## **ADDENDUM NO. 2**

Date: May 23, 2018

**Project: Hiram Johnson HVAC Replacement**

Sheet  
**E3.22**

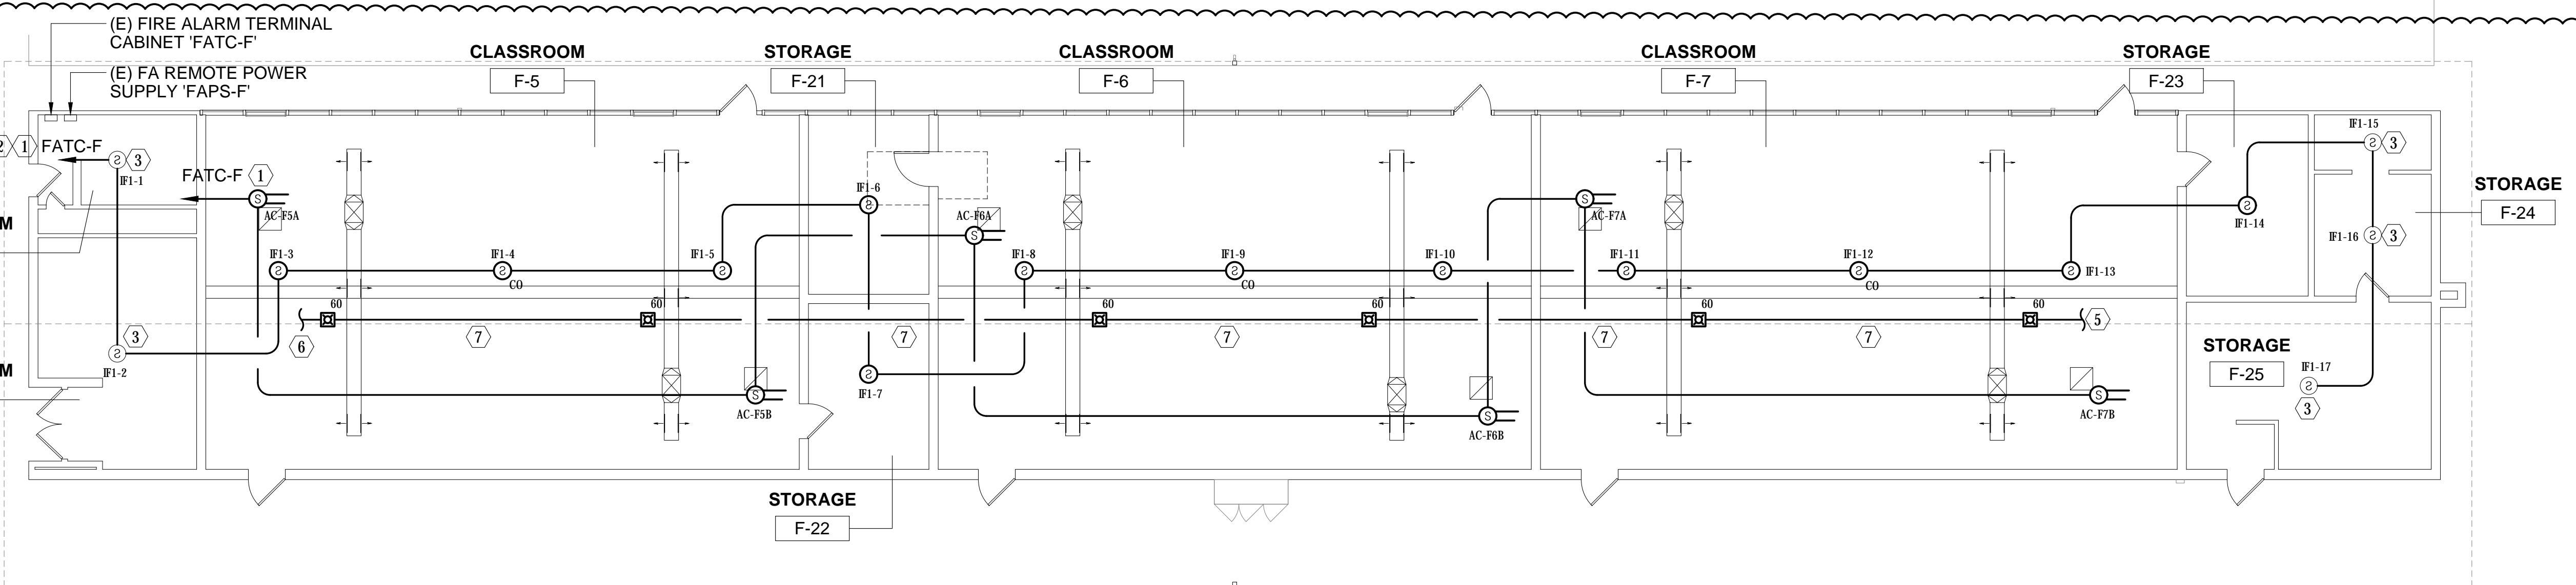
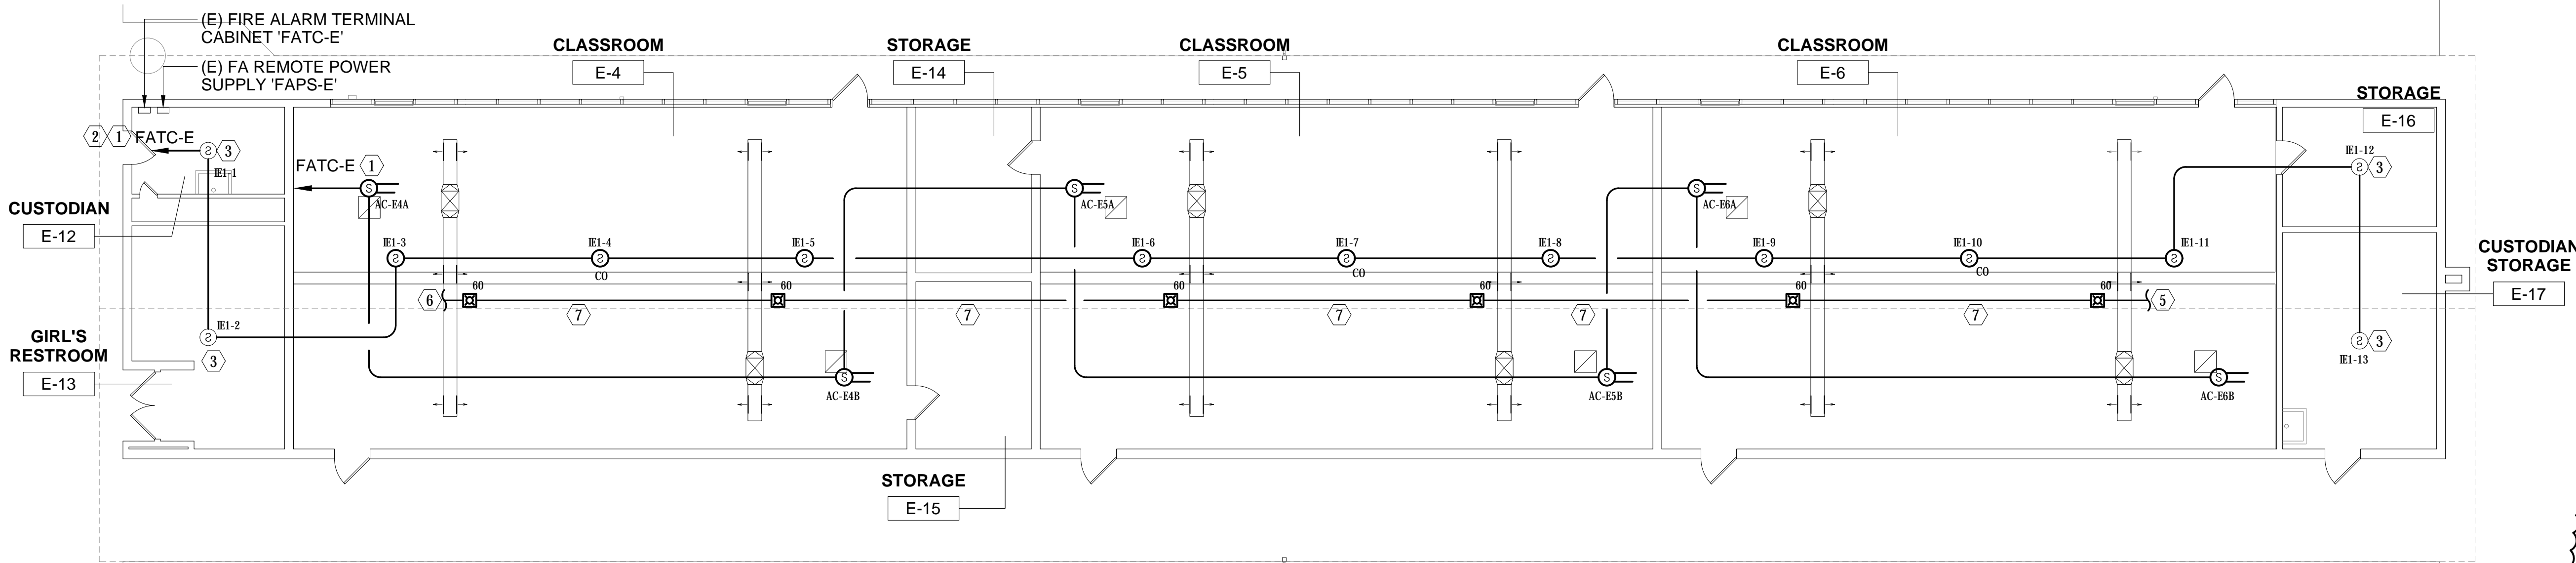
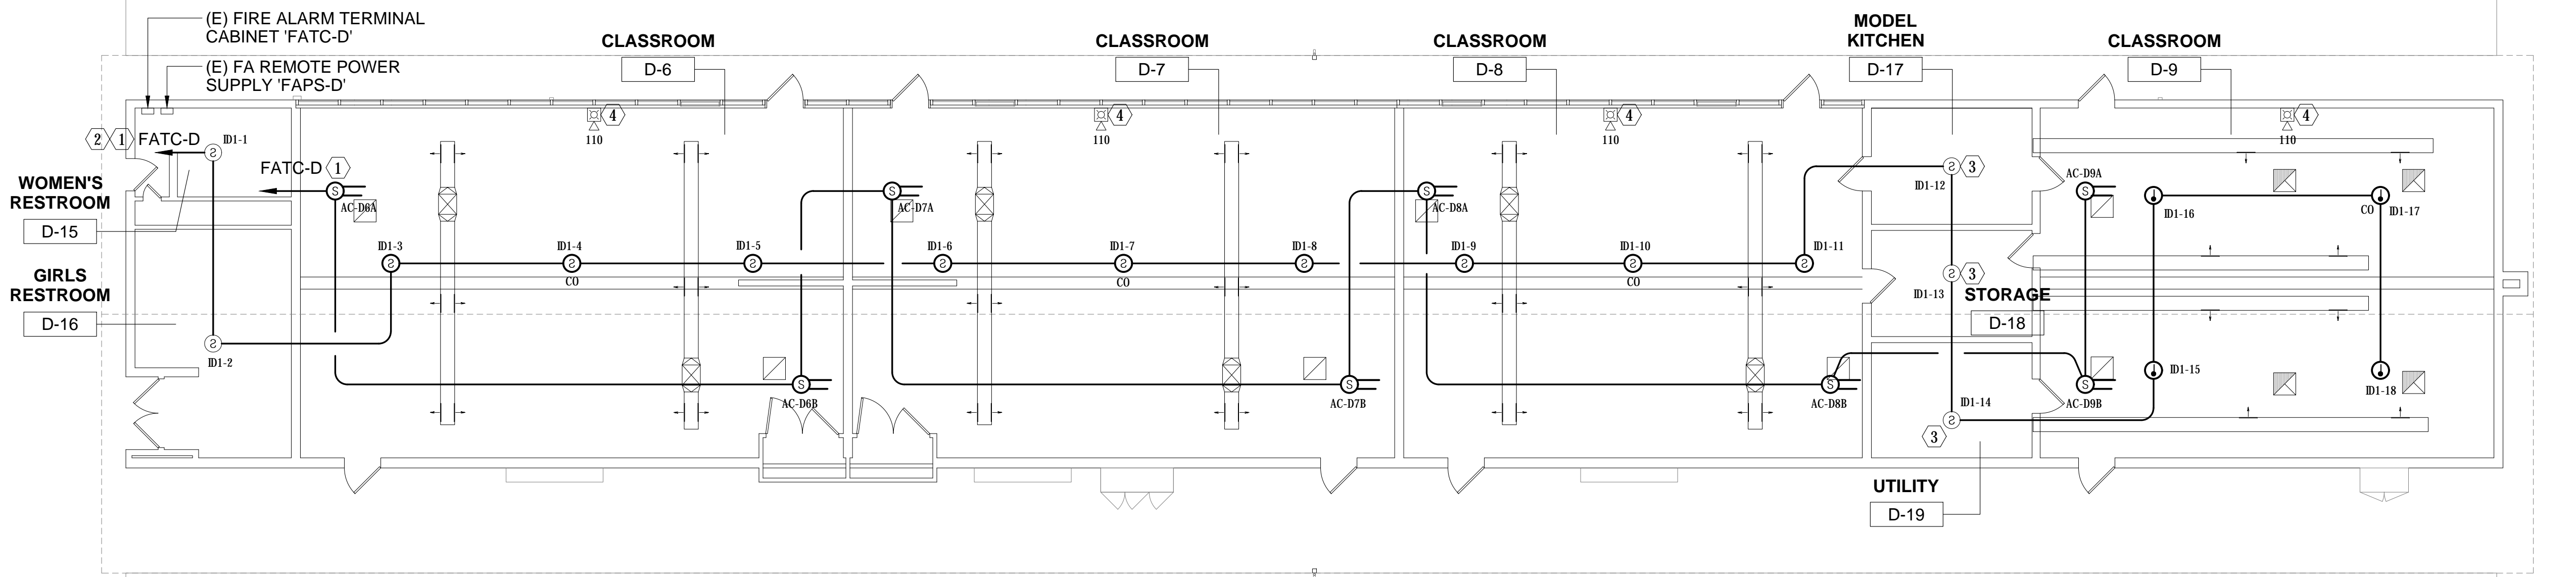
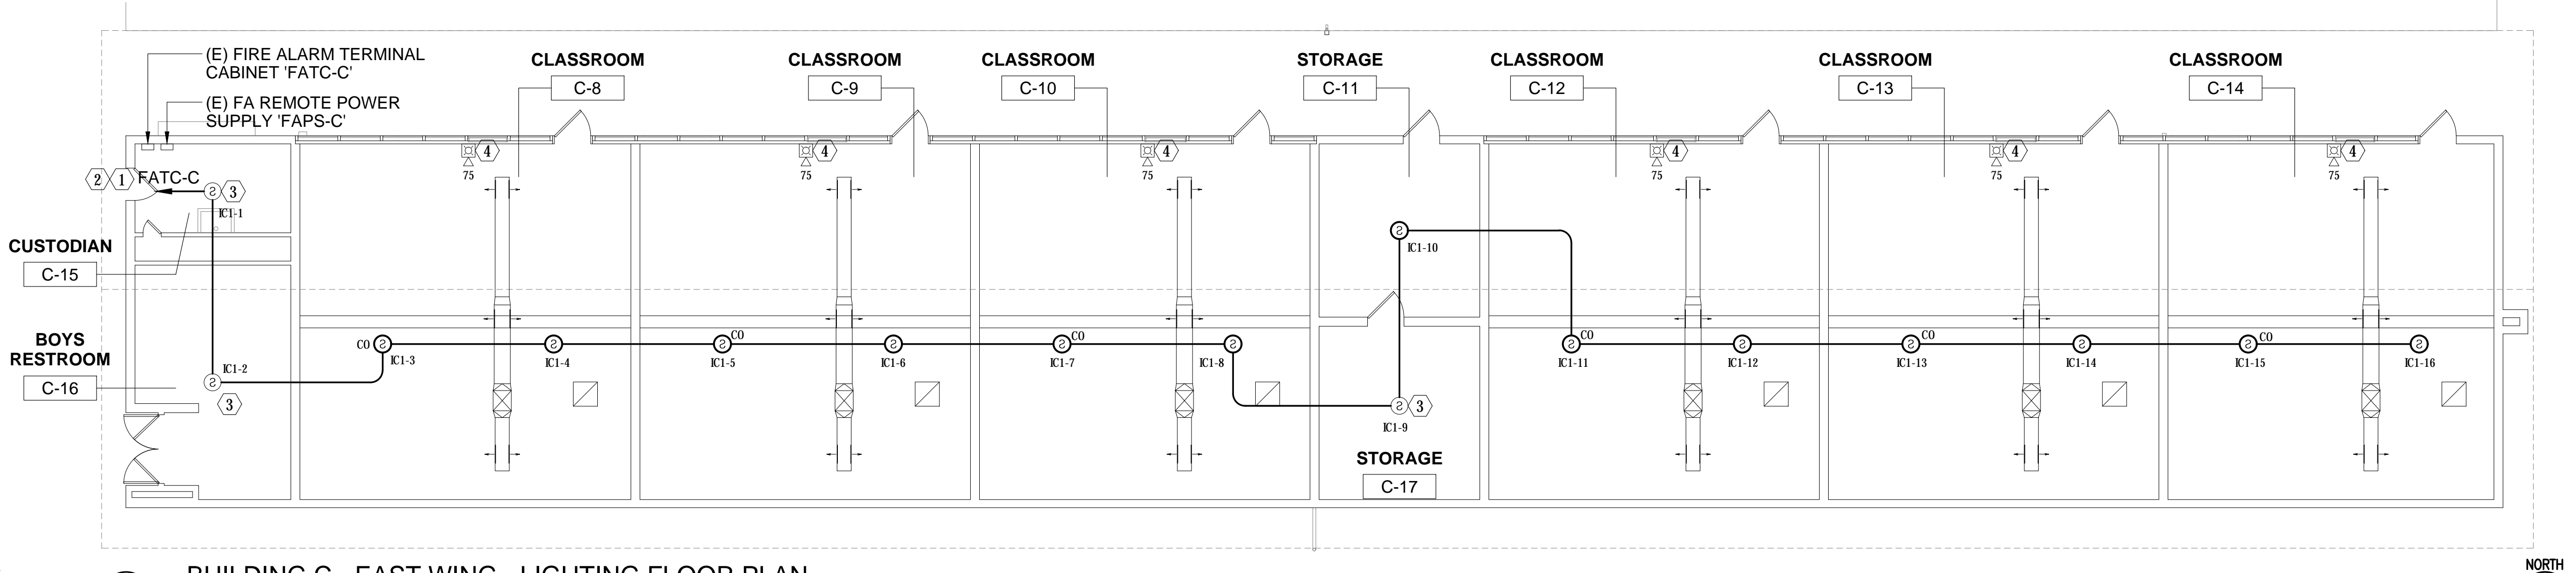
**Refer to Drawing Sheet E3.2.2**
